**Addendum No. 2**  
**March 15, 2017**

Project: **Canton High School Performing Arts Center Addition**  
Canton, South Dakota

Arch Project No.: 2621

Architect: Architecture Incorporated

**POWER RISER DIAGRAM**  
NO SCALE

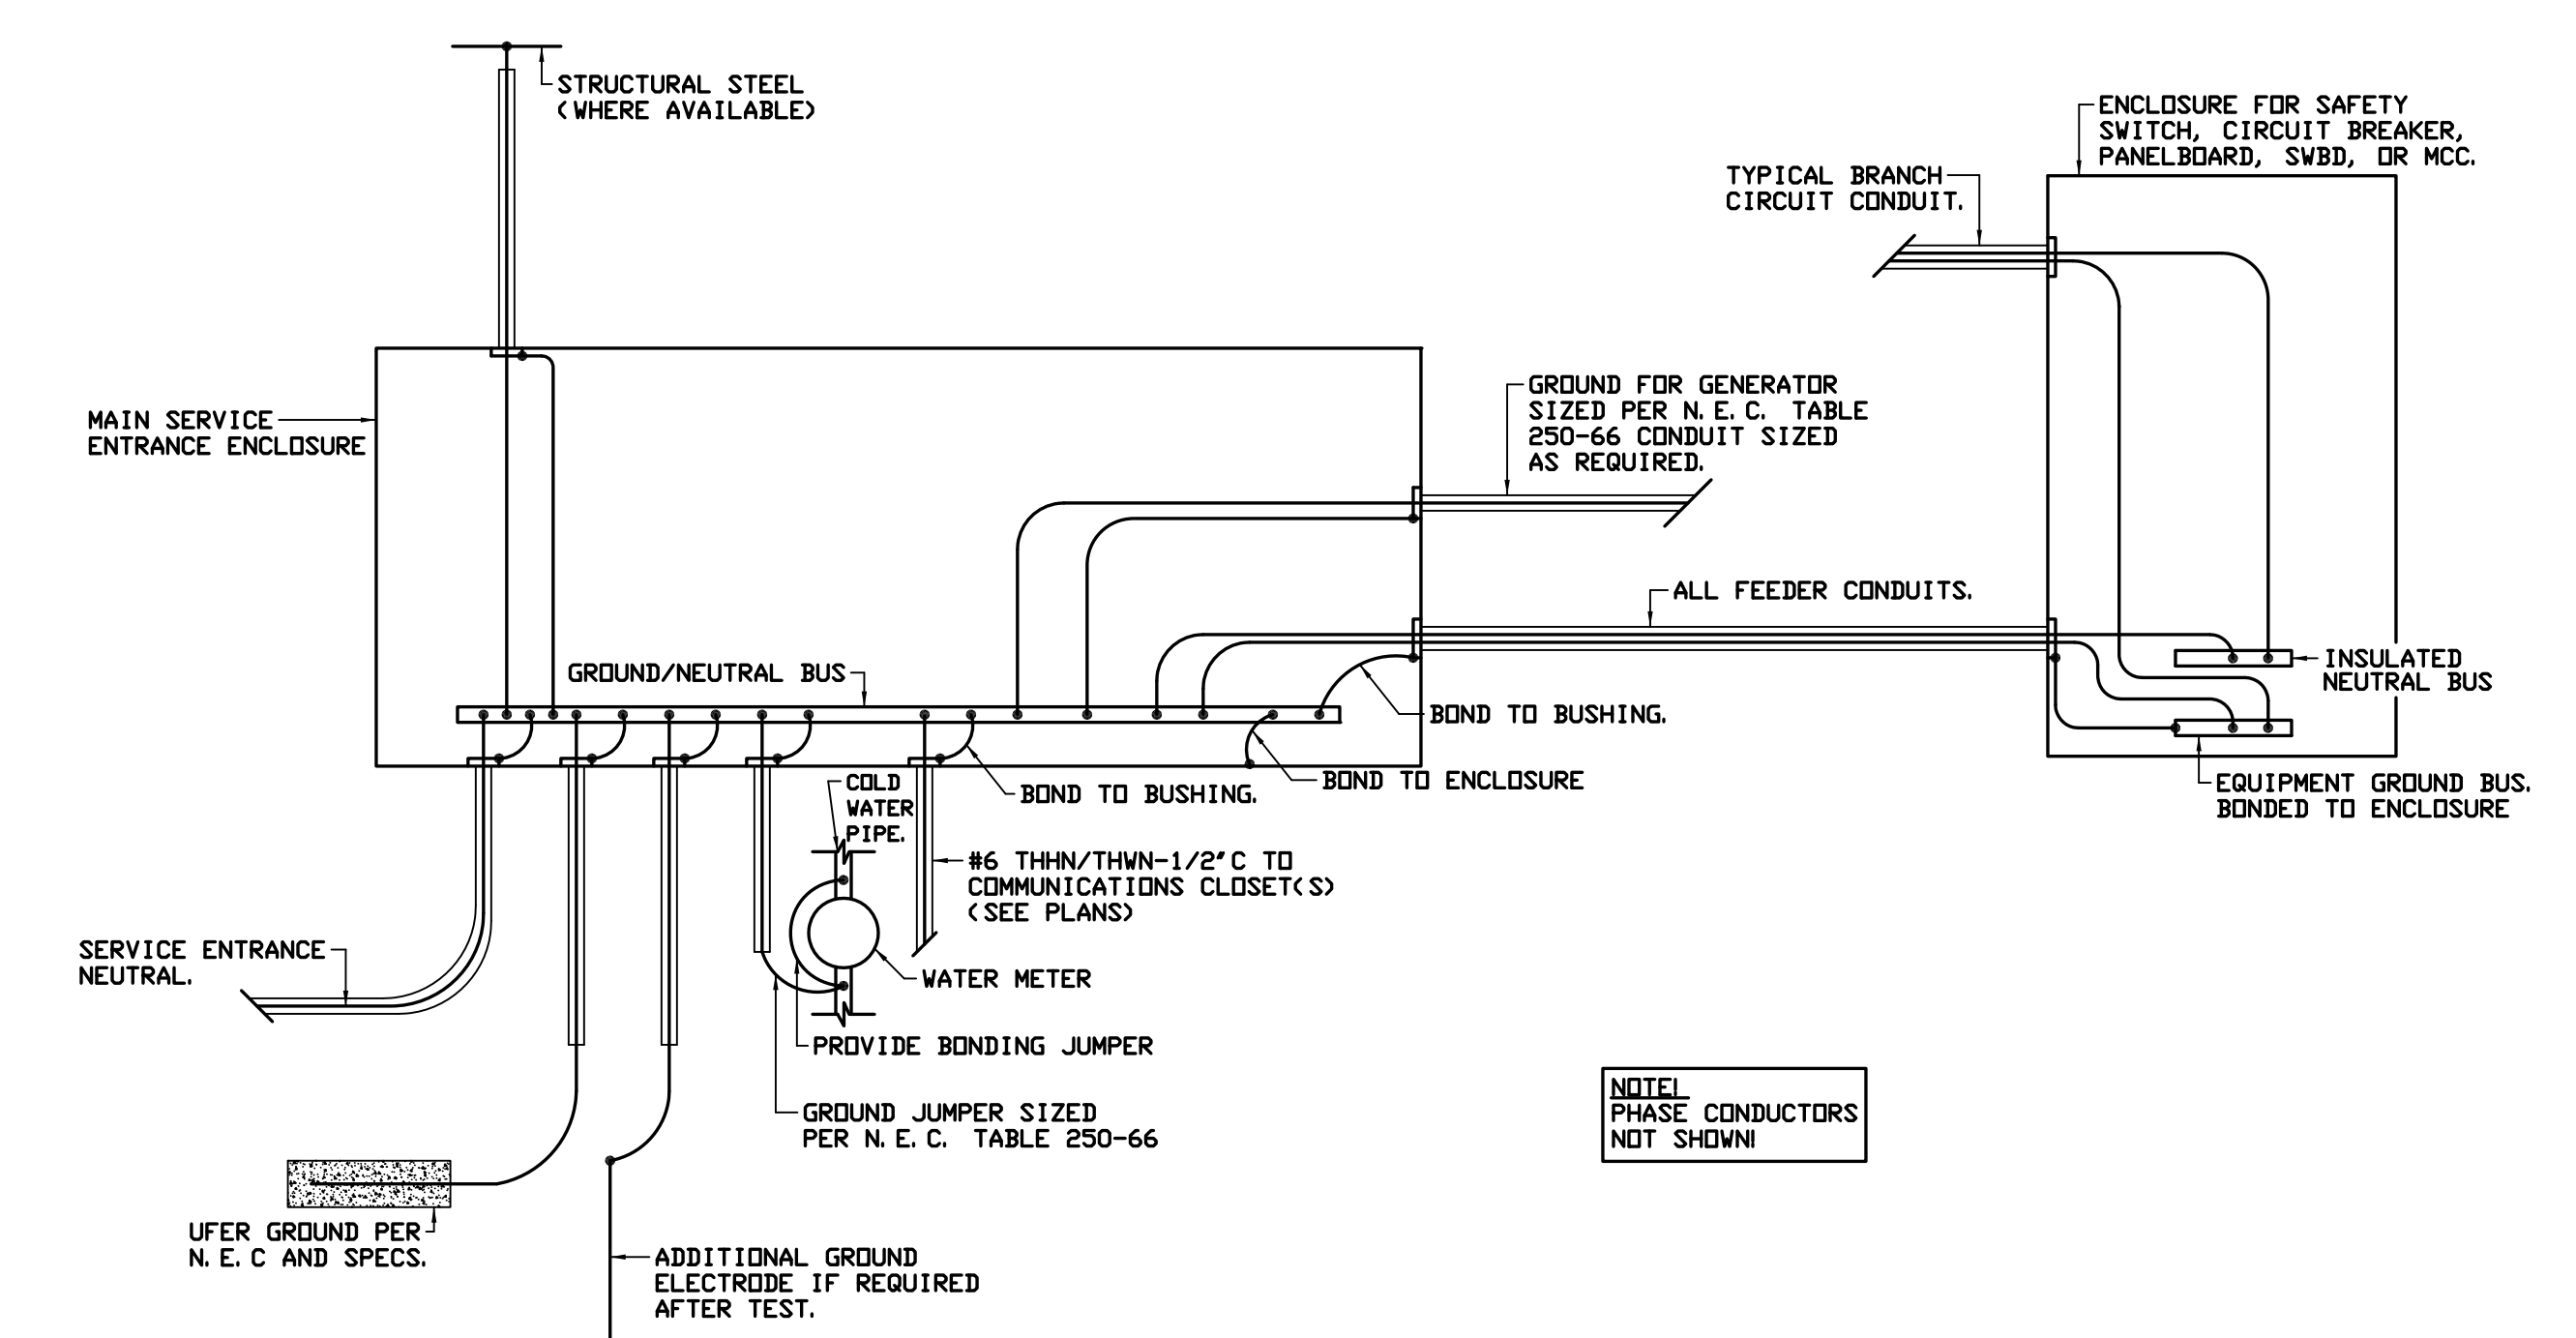
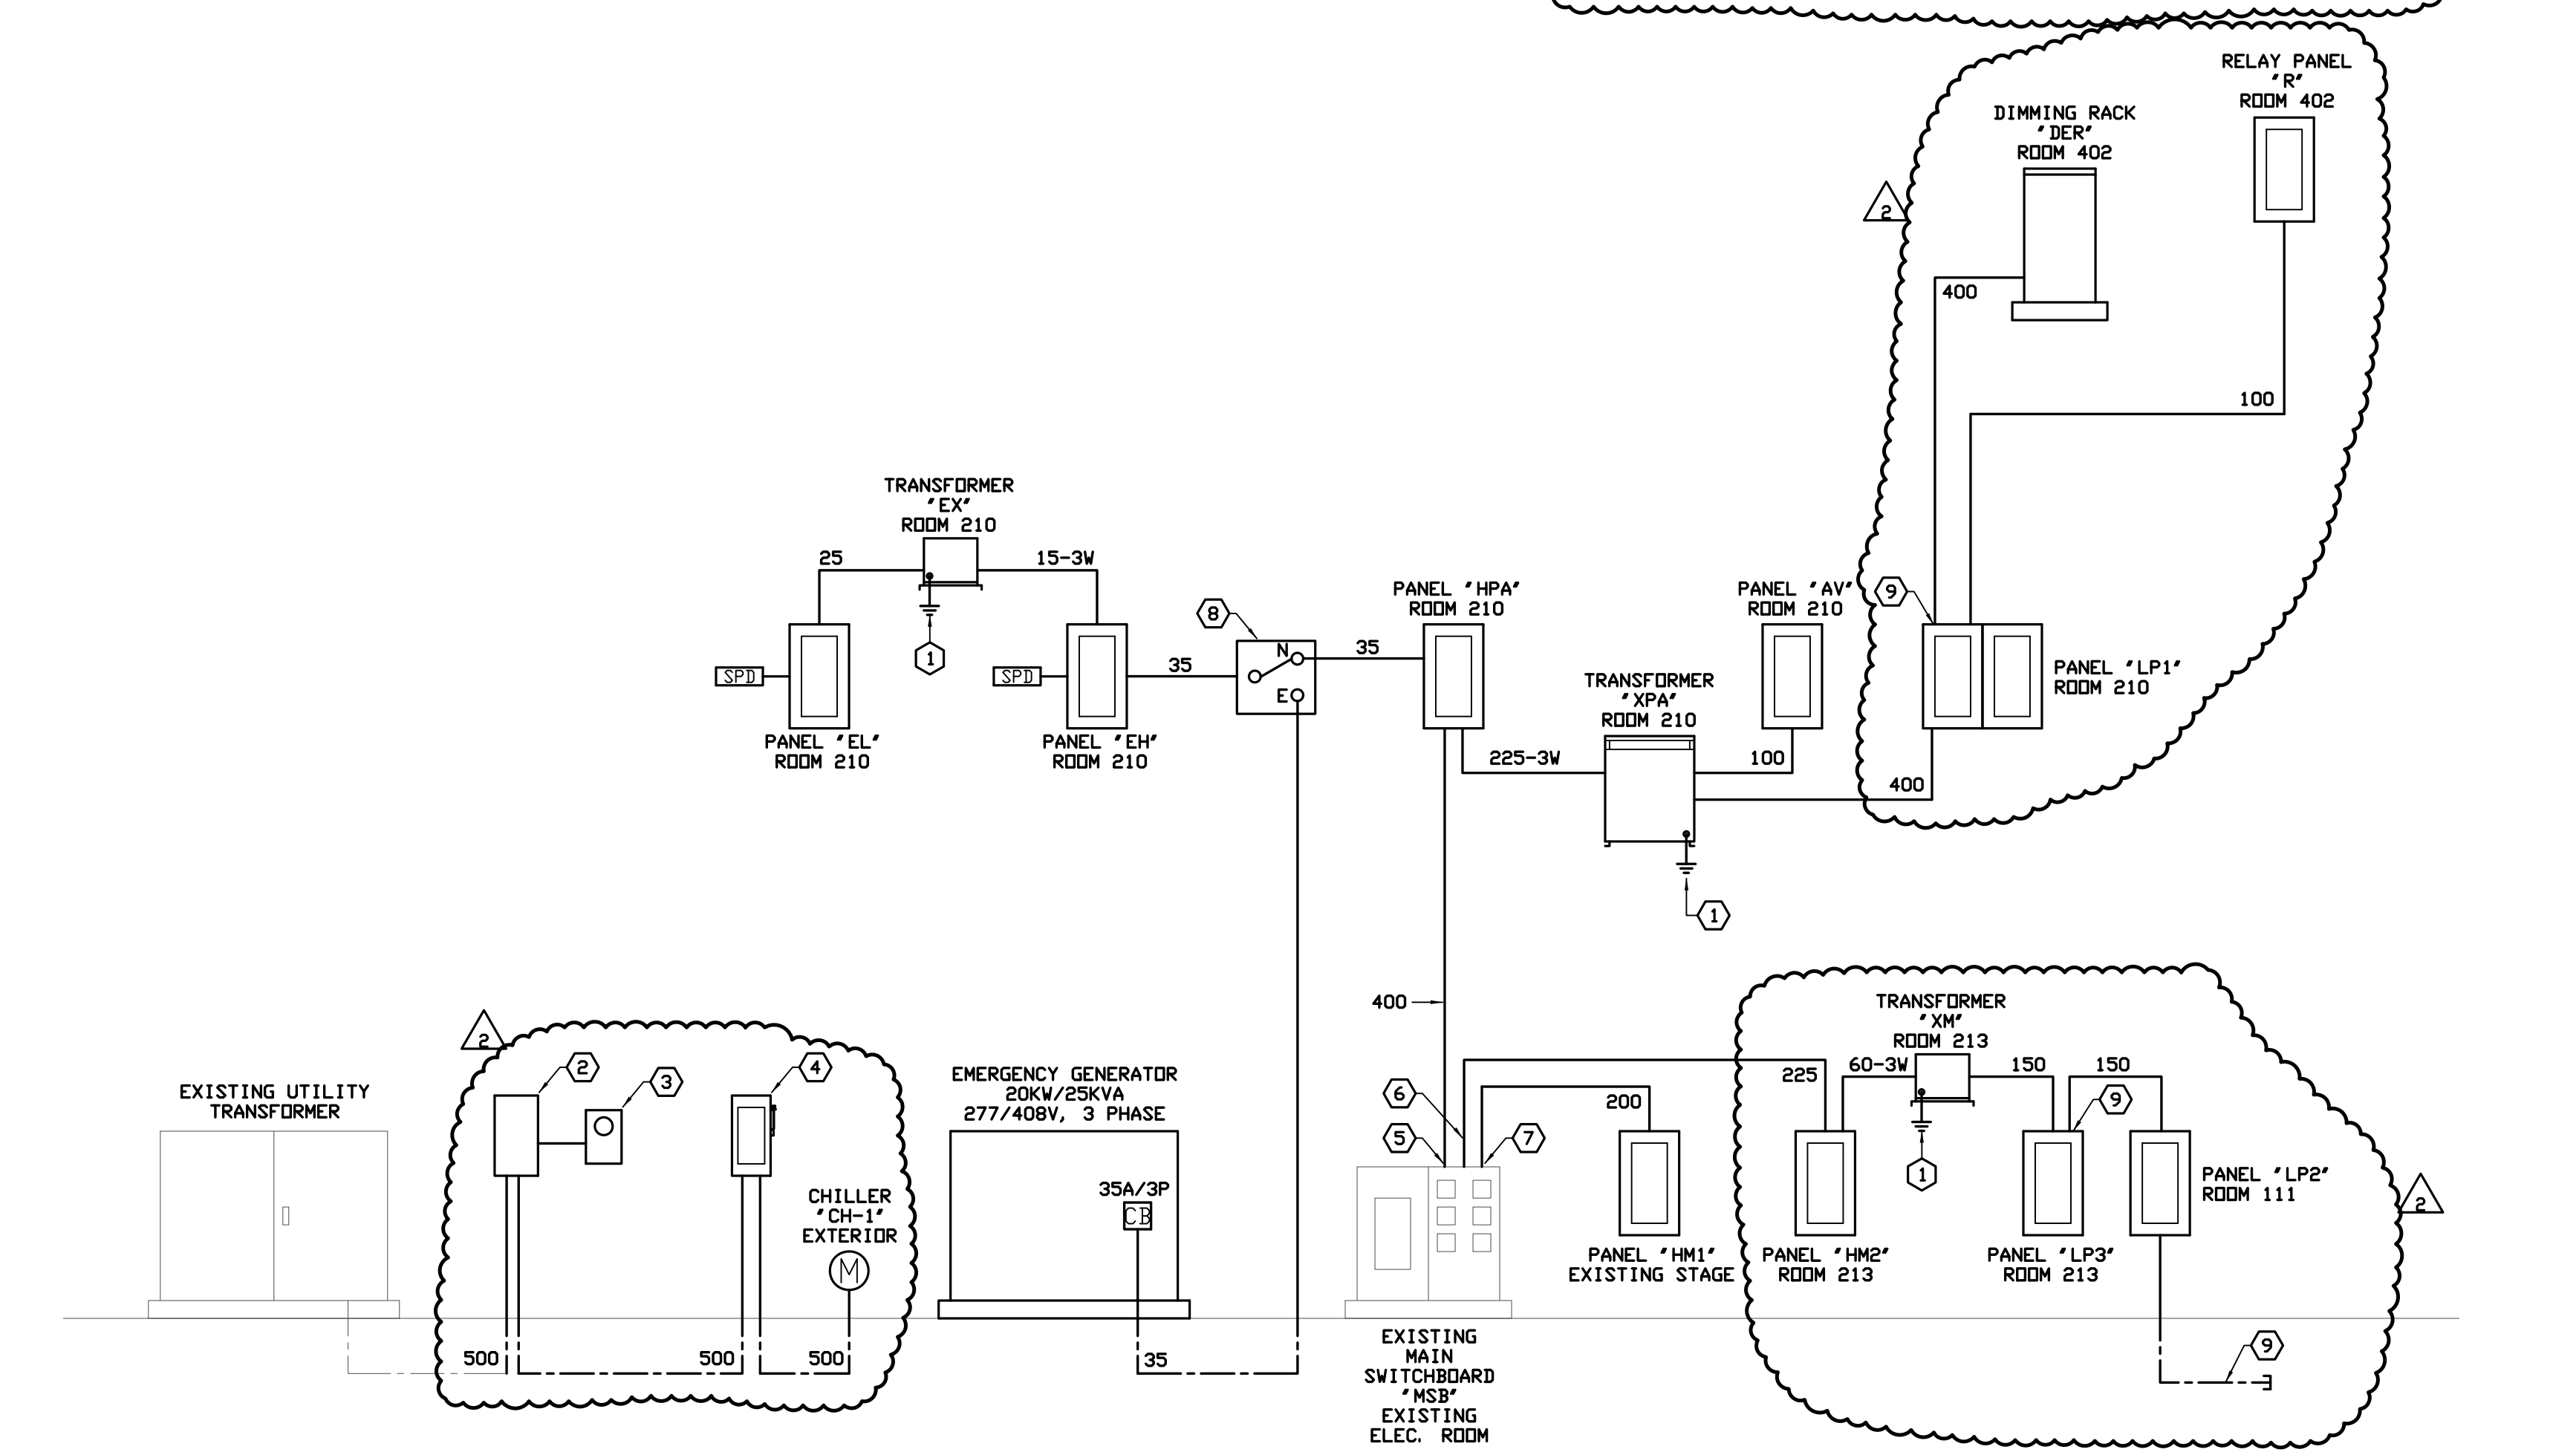
- 14) SHEET 9.72 – SCHEDULES & DETAILS
  - a) All bidders shall replace original electrical drawing Sheet 9.72 with *revised* Sheet 9.72 (dated 3-15-17) that is attached to the end of this addendum. *Revised* Sheet 9.72 shows a revised power riser diagram; disregard electrical Item #9 issued per Addendum #1.

- ELECTRICAL NOTES**
- GROUND IN ACCORDANCE WITH THE NEC, LOCAL CODE REQUIREMENTS, AND SPECIFICATIONS.
  - 600A CT CABINET BY ELECTRICAL CONTRACTOR (EC).
  - NEW UTILITY METER FURNISHED BY UTILITY INSTALLED BY EC.
  - 600A/3P FUSED MAIN DISCONNECT SWITCH "MDS-CH". FUSE AT 600A.
  - REPLACE EXISTING 300A/3P CIRCUIT BREAKER THAT FED RAHU-5 WITH A NEW 400A/3P CIRCUIT BREAKER.
  - UNDER THE BASE BID, PROVIDE A NEW 200A/3P CIRCUIT BREAKER (65,000 AIC). UNDER ALTERNATE #5A, UTILIZE THE EXISTING 200A/3P CIRCUIT BREAKER THAT FED RAHU-3.
  - UTILIZE THE EXISTING 200A/3P CIRCUIT BREAKER THAT FED RAHU-1.
  - AUTOMATIC TRANSFER SWITCH "ATS-LS", 60A/3P 14,000A AIC, ROOM 210.
  - PROVIDE FEED-THRU LUGS.
